NPDES PERMIT FACT SHEET
INDIVIDUAL INDUSTRIAL WASTE (IW)
AND IW STORMWATER

Application No. PA0246891
APS ID 460282
Authorization ID 1210157

| Purpose of Application | Renewal of Individual Permit to Discharge Industrial Stormwater. | | |

(Item 3 listed in the 1/4/2018 email. Revised Site plan with additional detail.)

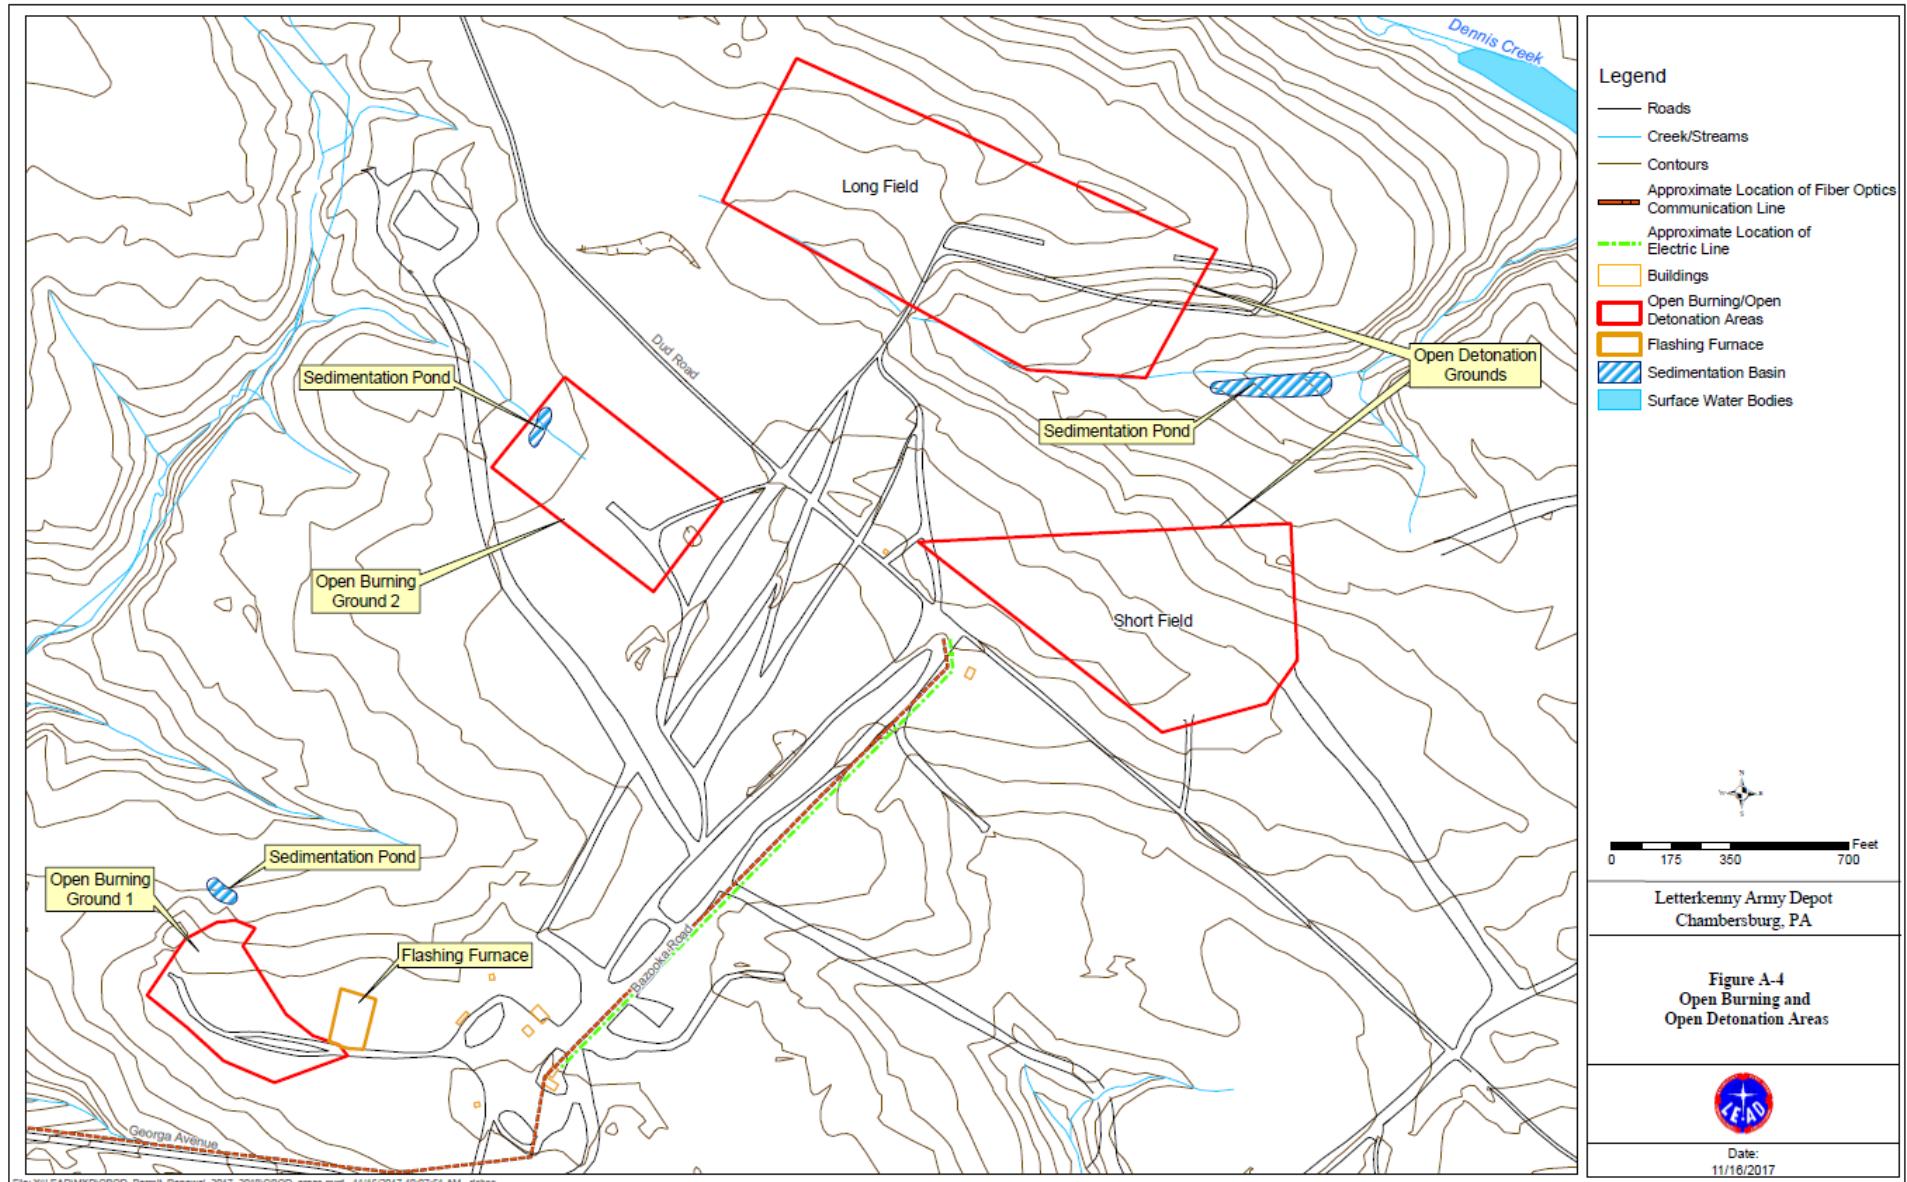
3. **Site Plan.** Attached a site plan that identifies structures, facilities, outdoor raw material, product and waste storage areas, drainage areas, discharge points , property boundaries and waters of the Commonwealth. The site plan included in the application package does not show drainage areas, property boundaries or waters of the Commonwealth. Please add these items to the site plan. (*see page 4 of the instructions)

1. Page 10 containing storm event information for Question 4 2. Certified mail receipts (one receipt was not received so the USPS delivery confirmation is included) 3. Site plan labeled "OBOD Areas". Waste ash is accumulated in the red "Open Burning Ground 1" area.
4. Topographic maps showing the entire Letterkenny property, the quadrangle showing the OBOD Grounds, and the location of the other stormwater outfalls. If there is still any information you need that is not shown, we can try to make a new map with what you need.

(Item 1.a. listed in the 5/22/2018 email. Revised Site plan showing outfall locations.)

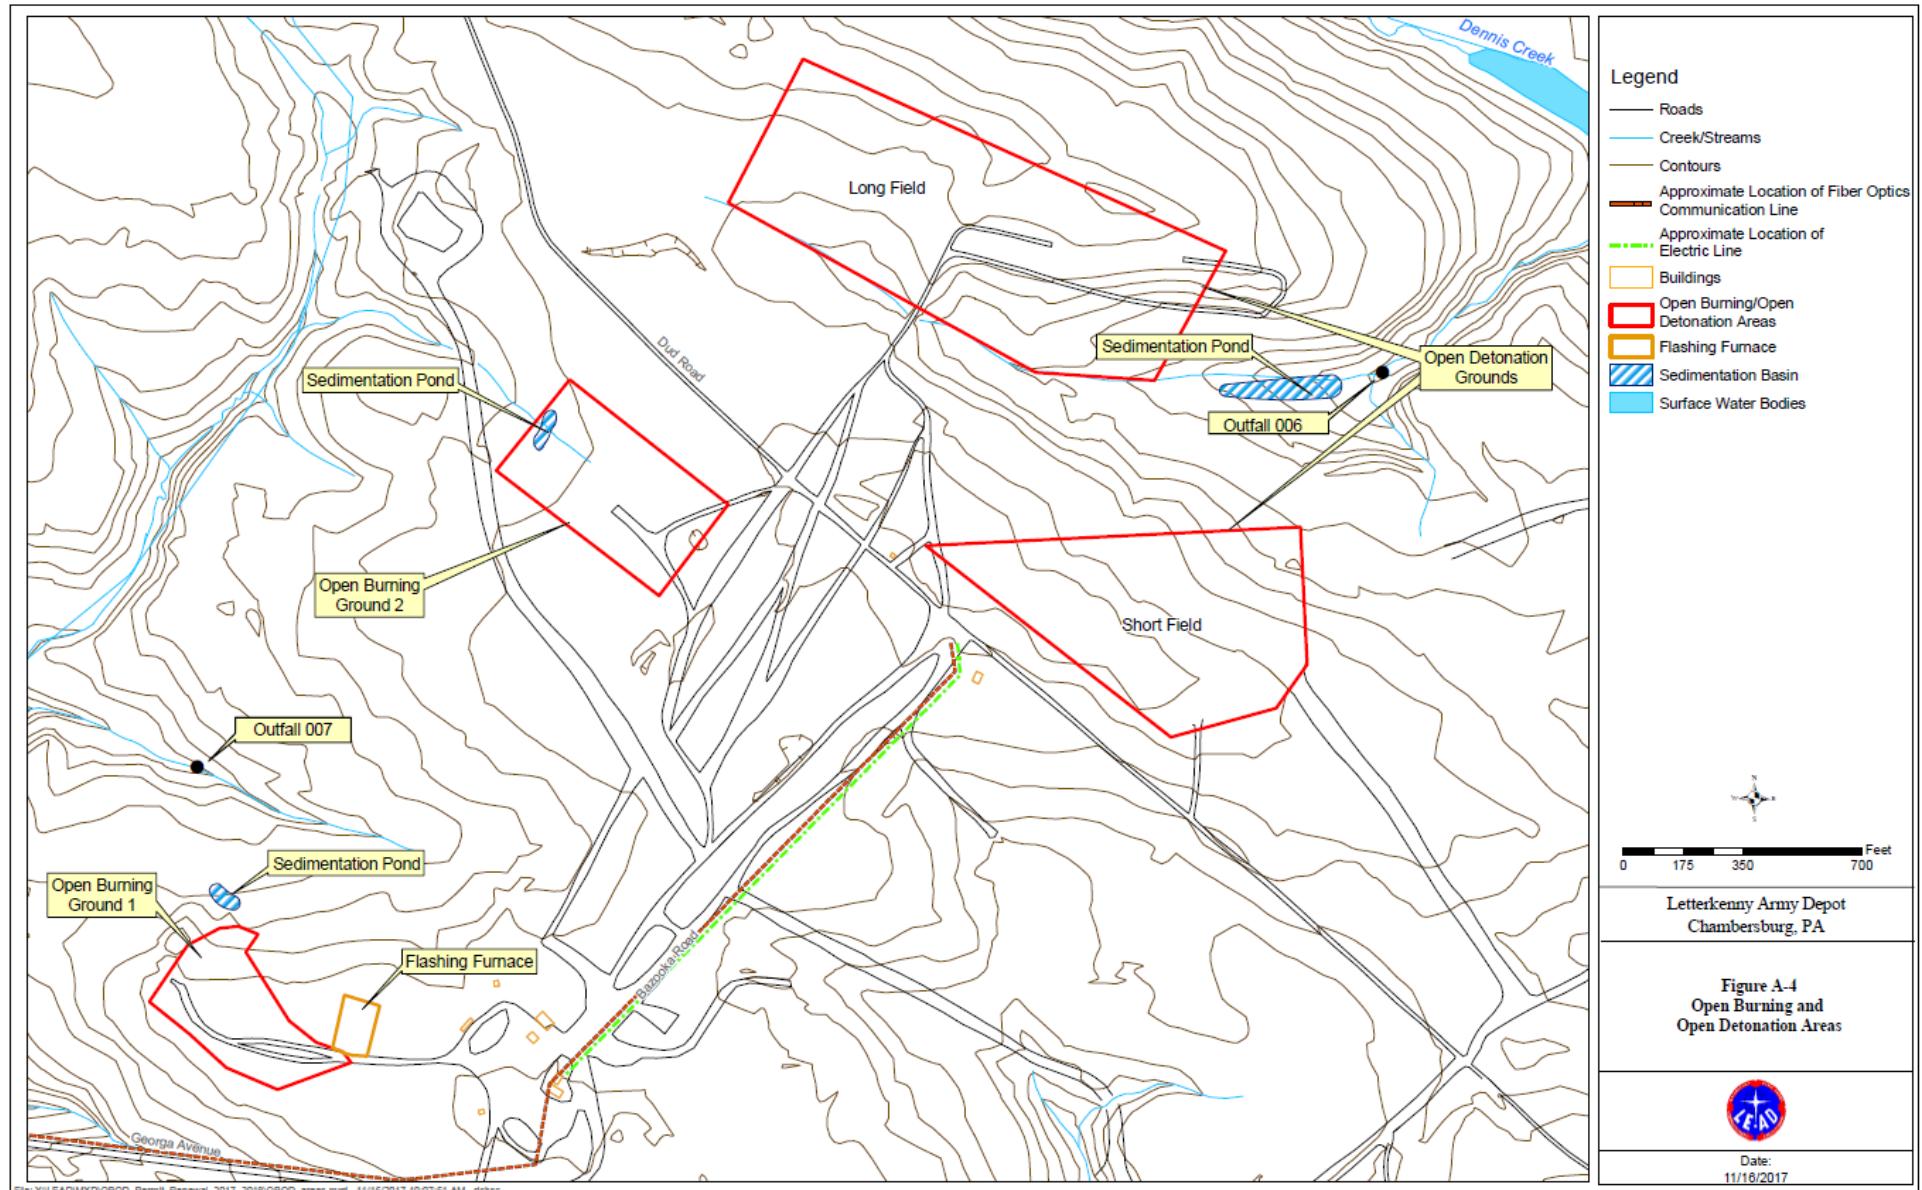
1. On Figure A-4: Open Burning and Open Detonation Areas, I have the following requests / questions:
 - a. Please locate and label Outfalls 006 and 007.

- b. Please show either on that site plan or another site plan how the stormwater the flow of the stormwater from the different areas of the site to both Outfall 006 and 007?

- c. The application indicates that the open burning and open detonation areas all go to Outfall 006. Does this include all the areas outlined in red on the site plan? If so, how does the stormwater get from Open Burning Ground 1 and 2 to Outfall 006?

- d. The application indicates that the flashing furnace is the only area that drains to Outfall 007. Is this correct? If so, how does the drainage area reach 409,077 sq. feet as indicated in the application?

(Item 1.b. listed in the 5/22/2018 email. Direction of stormwater flow at the OB/OD grounds.)

(Item 2. listed in the 5/22/2018 email. Topographic map of the entire Letterkenny property with Outfalls.)

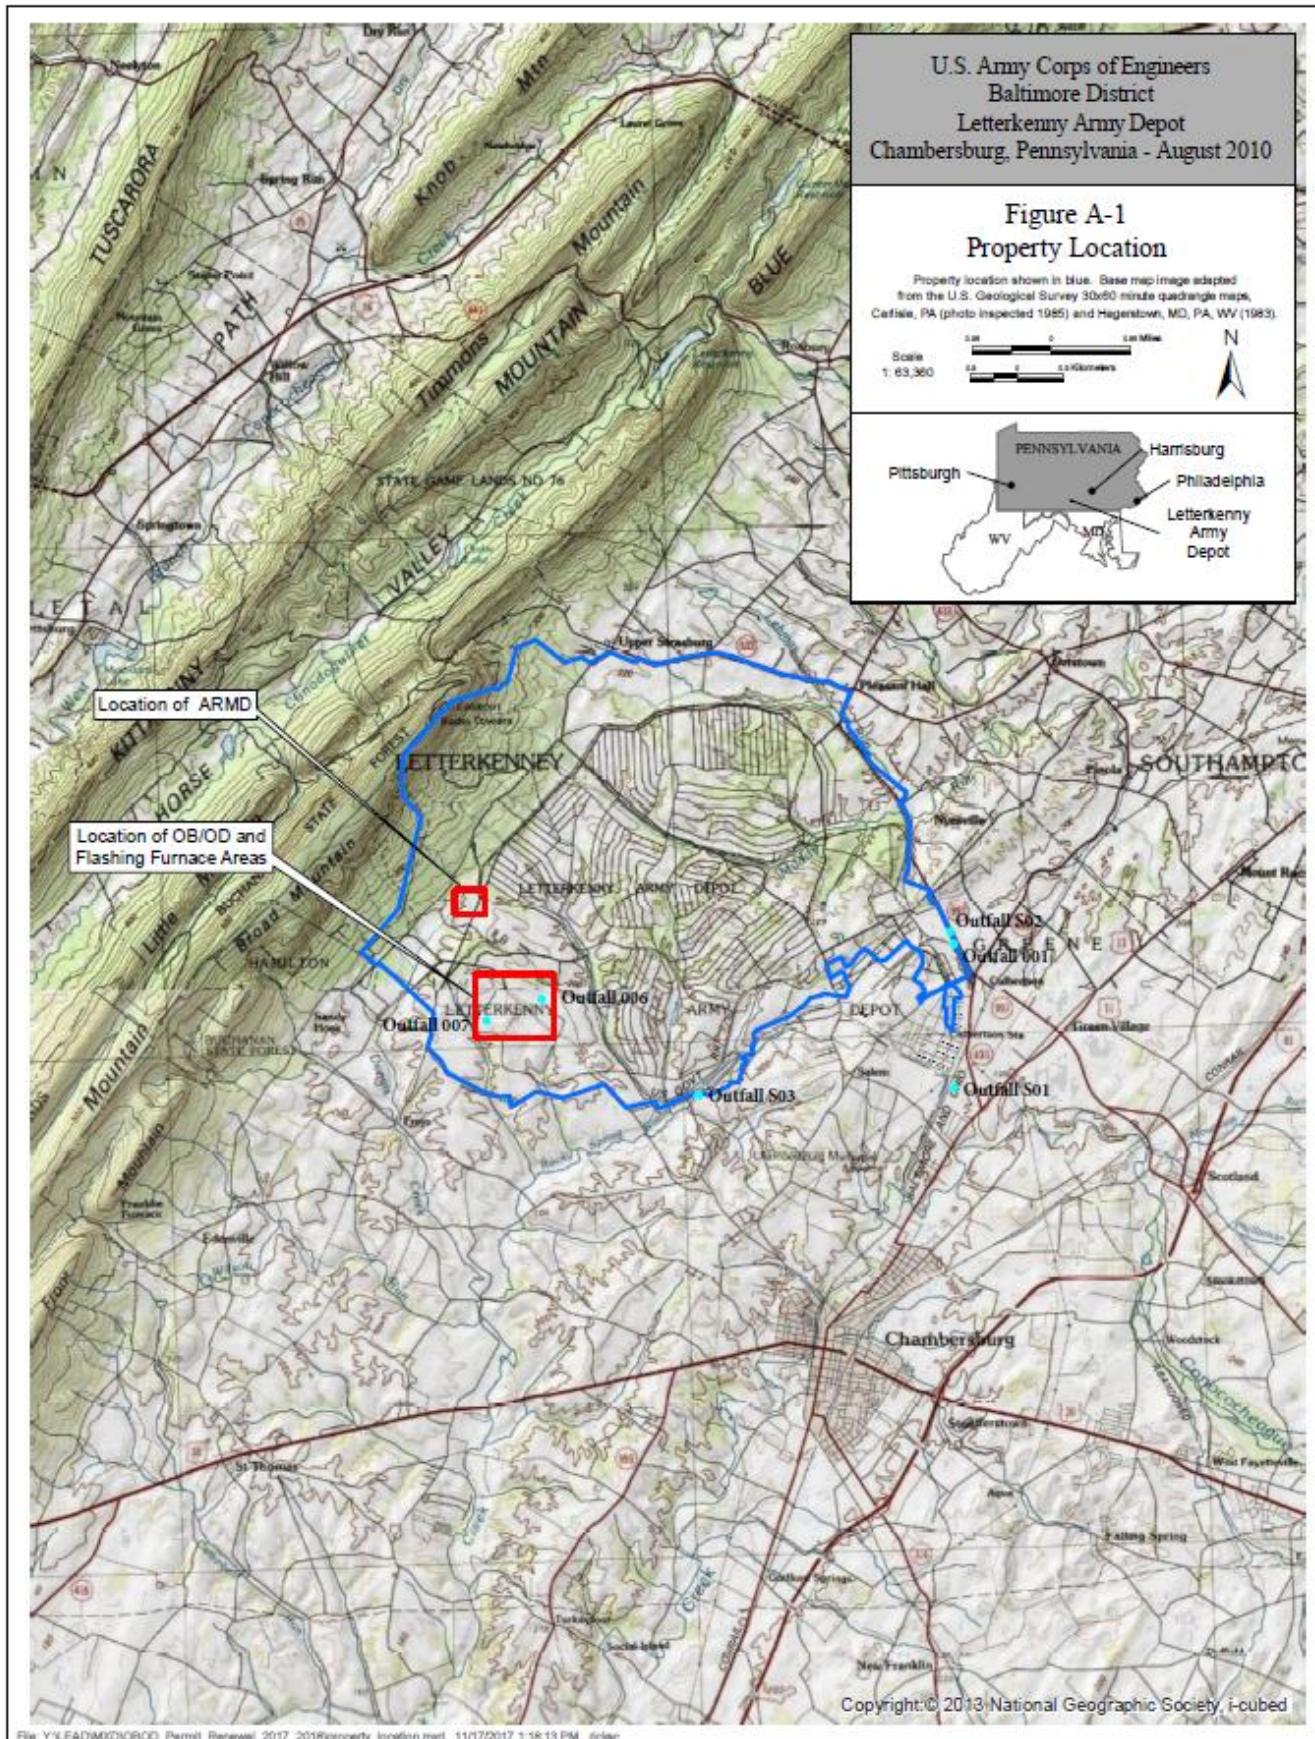
2. On Figure A-1: Property location, would it be possible to identify and label all the outfalls? This would help me better picture how everything fits together.

(Item 3. listed in the 5/22/2018 email. Topographic map showing the OB/OD grounds with Outfalls.)

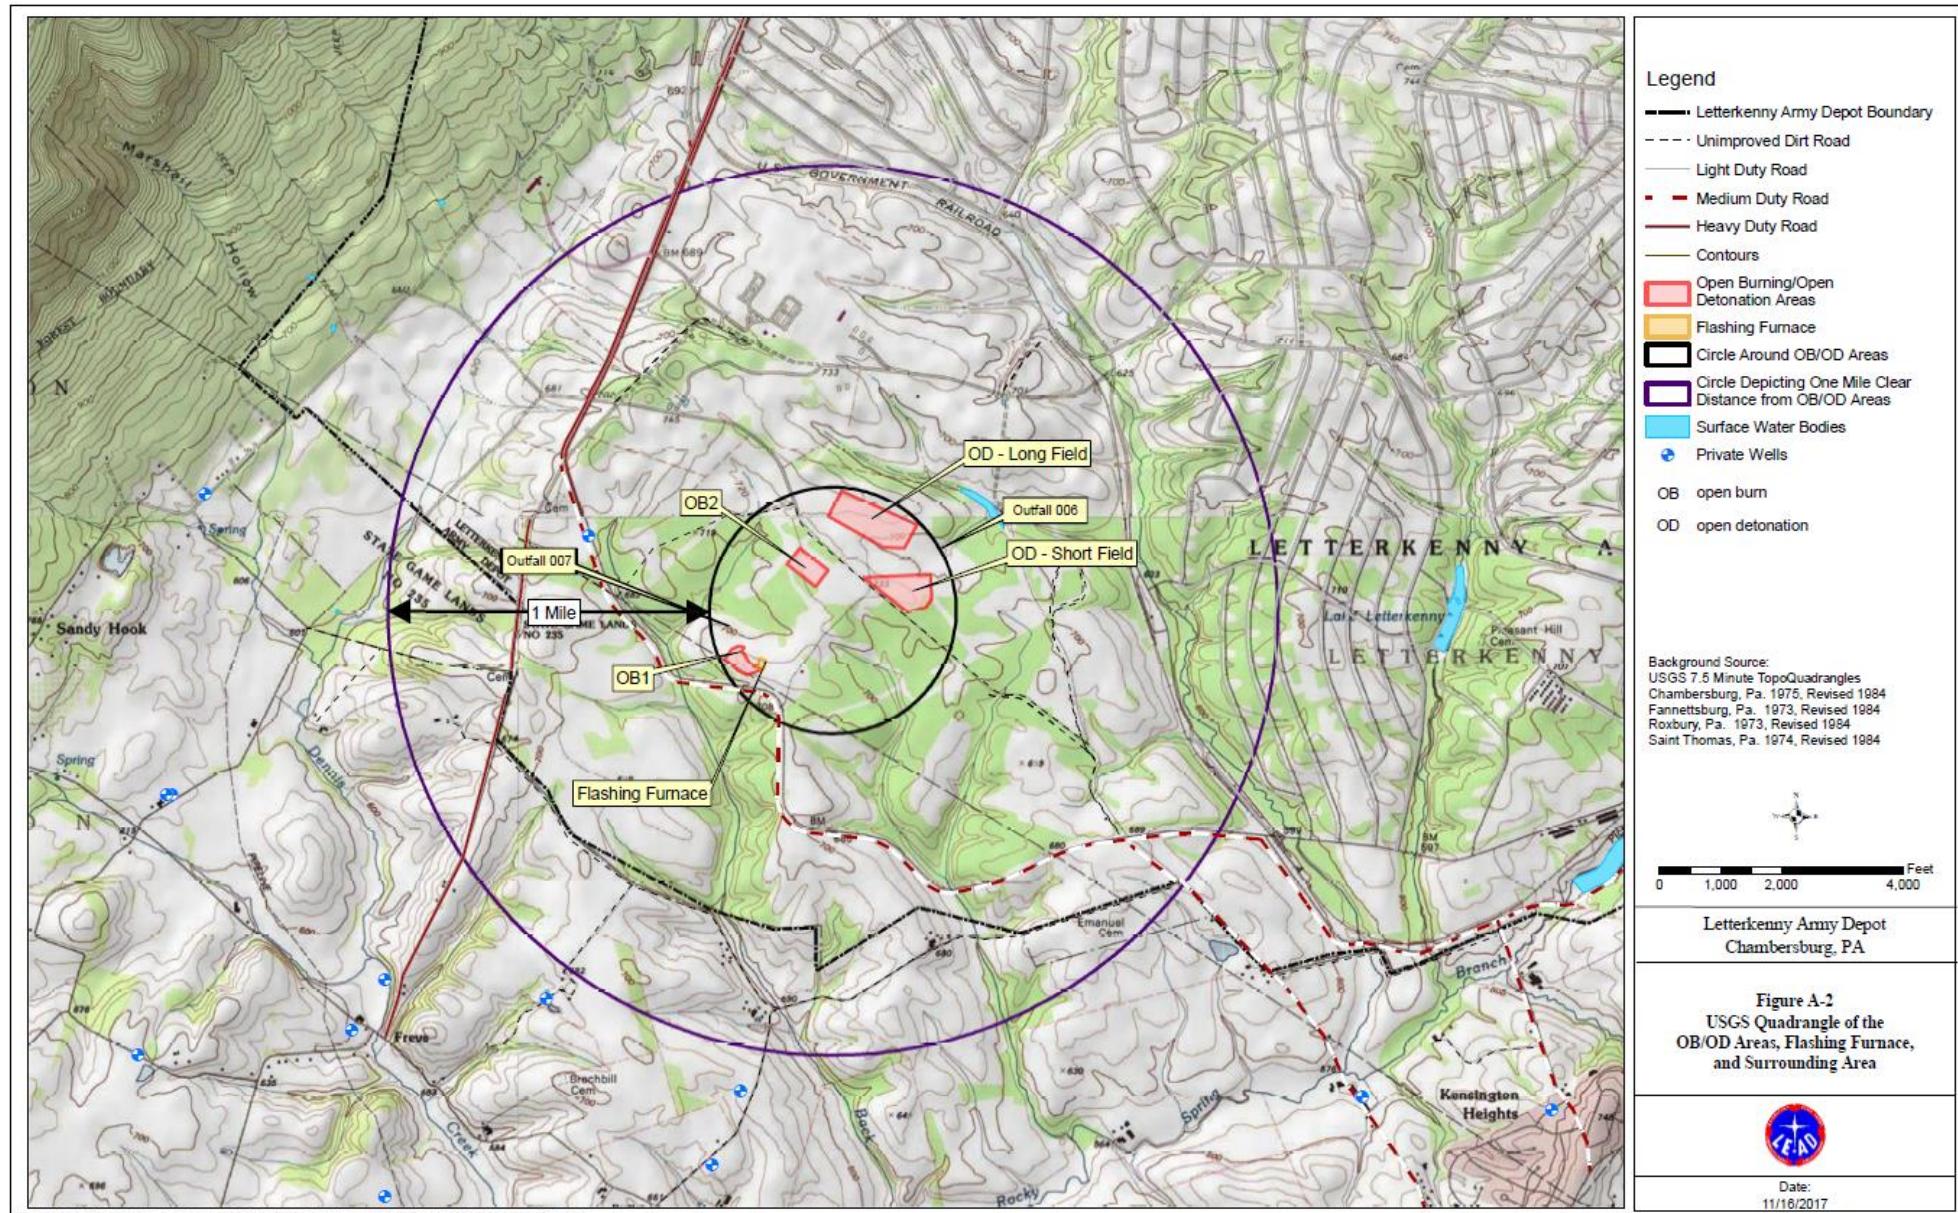
3. On Figure A-2: USGS Quadrangle of the OB/OD Areas, Flashing Furnace, and surrounding areas, would it also be possible to show outfall 006 and 007?
